GK Garments Ltd (10378)
Global Fashion Garments Ltd (10380)
Global Outerwear Ltd (9991)
Savar Shirts (10394)

89, Berulia Road, Tati, Savar, Dhaka, Bangladesh.

20.MARCH.2014

Identified Priority 1 Concerns

Excessive Storage Height of Garments

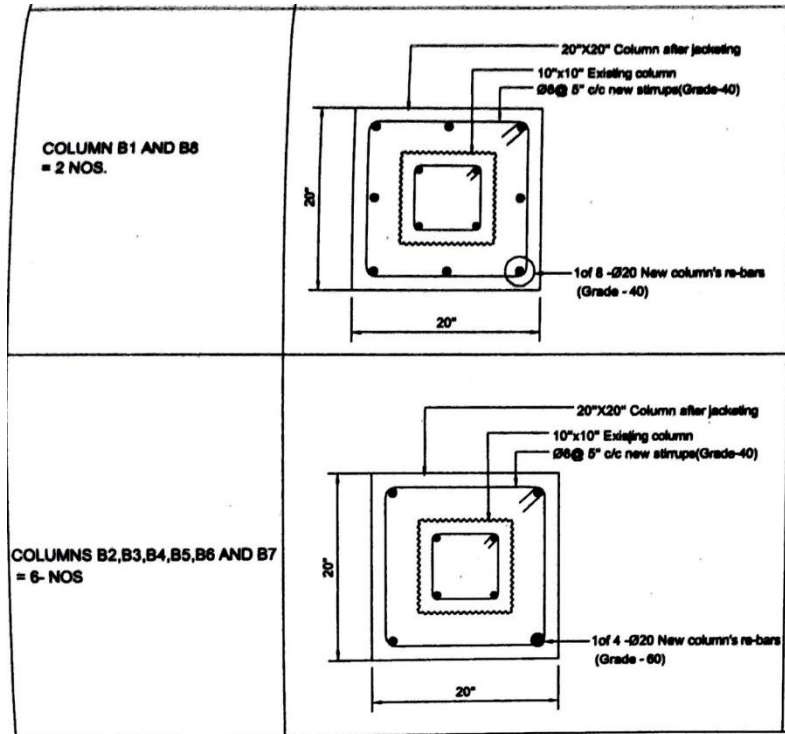
In many areas of the building, clothes have been stacked to unreasonably high levels despite there being plenty of space available to stack the clothes over a wider area.

The clothes should be stored such that the live load does not exceed 3kPa for any particular slab panel.

- Redistribute garments around the floor area to ensure that no stack exceeds 300kg/m²

Size of column B2 of Block B differs between site and drawings

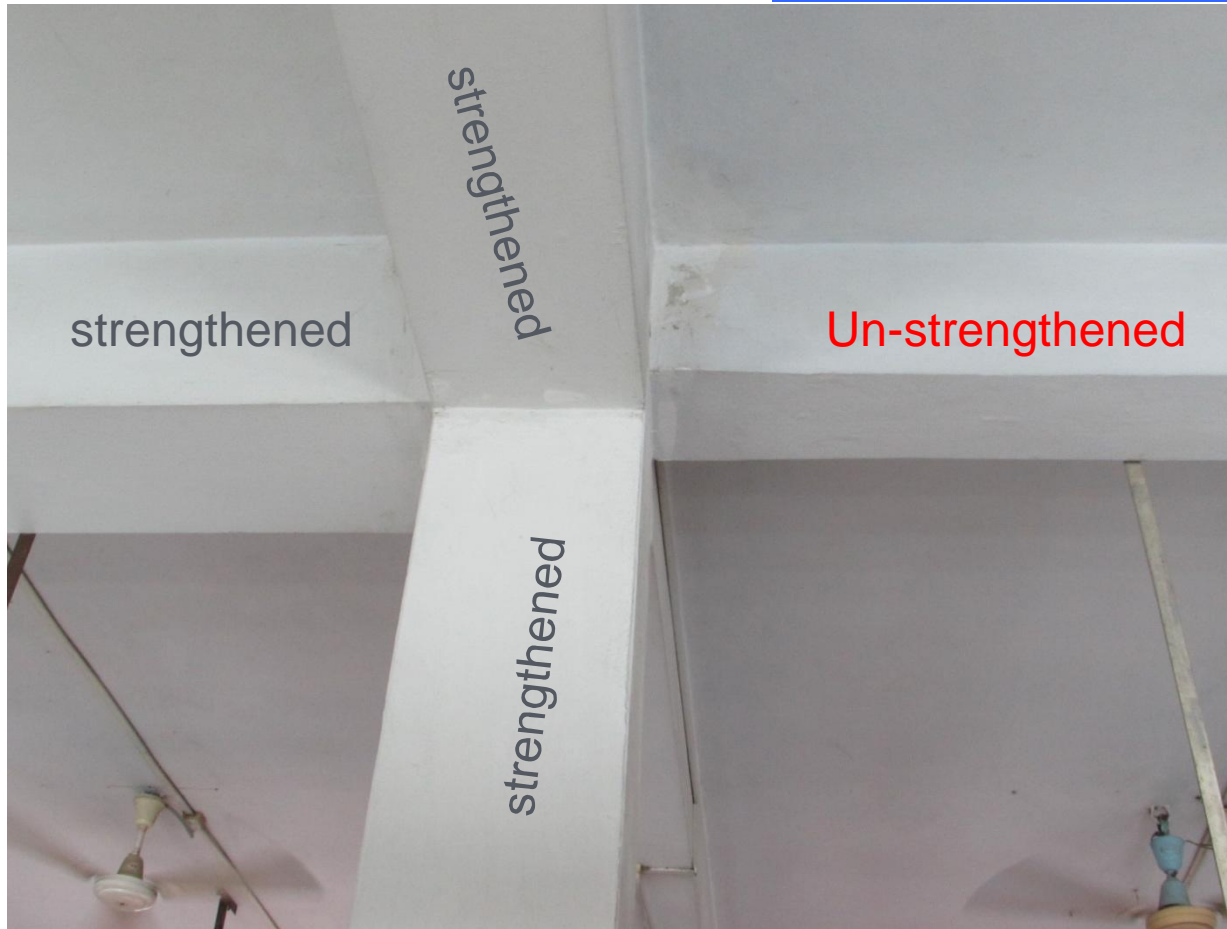
The drawings show that column B2 is a 508x508mm column, but the dimension on site only shows 381x381mm. As this is a supposedly “strengthened” column, we cannot see any evidence of this, even if the original column size was perceived to be 254x254mm. However, the building engineer has assured us that strengthening works have taken place.

- Factory Engineer to review design, loads and columns stresses in all areas
- Verify insitu concrete stresses either by 100mm dia. cores or existing cylinder strength data.

- A full structural survey of the building is to be carried out using intrusive and non-intrusive methods to ascertain the overall accuracy of the existing record drawings.

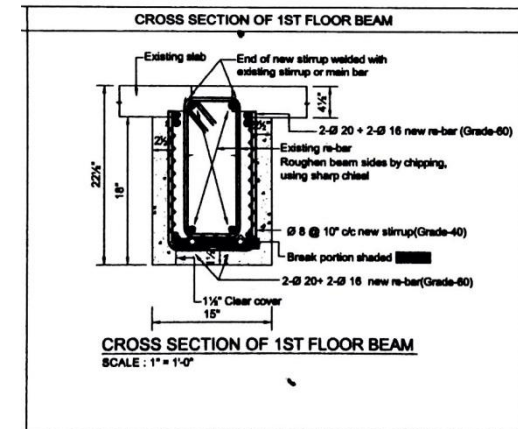
The upgrade of the existing Block B included the strengthening of all the existing beams to upgrade the imposed load capacity, and to strengthen them to due to the increase in building height and increase lateral load resistance from wind and seismic forces. However, there are some beams on G/F ceiling which have been selectively omitted from strengthening, and there seems to be no reason for this.

- Building Engineer to carry out full assessment of structure to ascertain reason for the beam not strengthened.
- A full structural survey of the building is to be carried out using intrusive and non-intrusive methods to ascertain the overall accuracy of the existing record drawings.
- Carry out strengthening works if found necessary

Numerous Structural Defects have Appeared in Block B

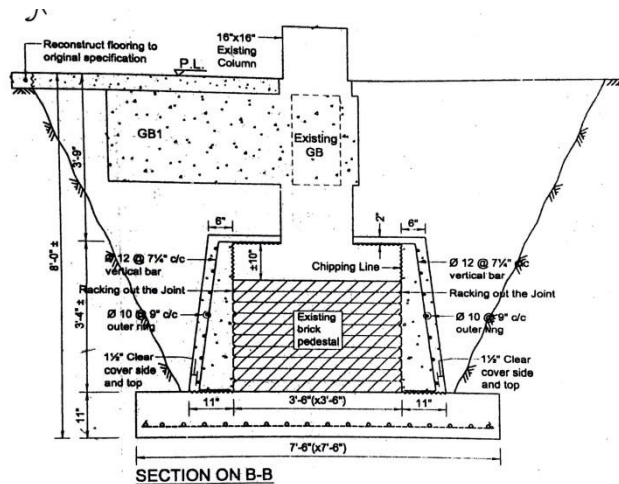
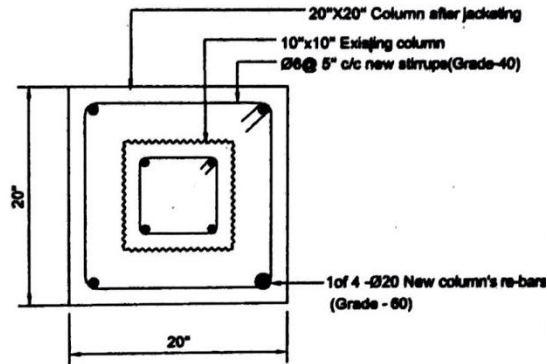
This building has a total of three buildings joined together. Each building is separated by a movement joint. However, it can be seen at several locations that excessive deflection of the structure has caused significant differential settlement.

In other areas, the upper floors have smaller beams than the lower floors, and also thinner slabs (some as thin as 88mm). The upper floor beams of Block B only show significant signs of cracks.

Exposing one of the beams revealed that honeycombing of the concrete could be a reason for some cracks appearing.

- In accordance with the actions in Item 2, carry out survey to ascertain the reasons for the defects observed,
- Propose remedial measures for the defects

Strengthening Design Works Appear Fundamentally Flawed

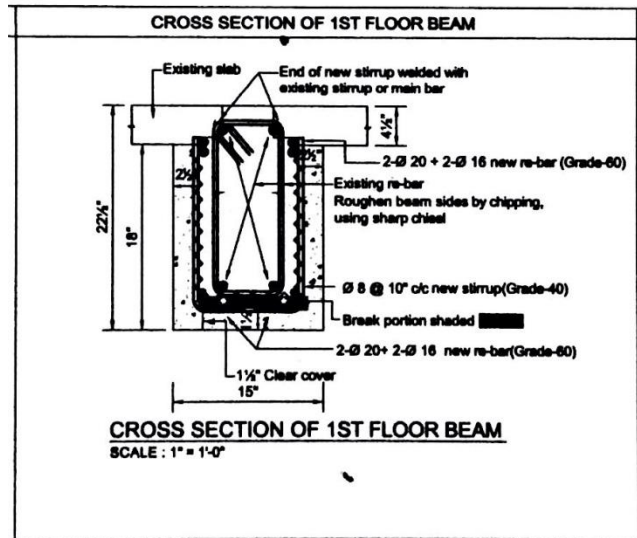
The perceived quality of the drawings, in particular for the strengthening works for Block B appear to be unsatisfactory. Although strengthening works have been proposed, it is felt that the design of the strengthening works is fundamentally flawed.

- Rebar spacing exceeds maximum
- Concrete grade of new concrete and steel grade of new rebar maybe significantly stronger than the original concrete and rebar causing unbalanced stiffness distribution and possible concentration of stress at concrete interface
- It is considered that brick and mortar is not a suitable medium to transfer column loads from the original pad footing to the new pad footing.
- It is also considered that 11 inches for the new footing is too thin given that it would be almost impossible to guarantee even ground compaction underneath the footing

- The new concrete jacket around the existing beam as well as the rebar may be significantly stronger than that of the existing beam, thus causing unbalanced stress distribution throughout the beam.
- The stirrup does not enclose the whole beam, and the jacket only relies on the bond between the old and new concrete, which may develop overstress due to the unbalanced stress distribution.
- There is insufficient bond length of the stirrup into the slab.

- Building engineer required to produce full calculations and justifications for the entire strengthening works design
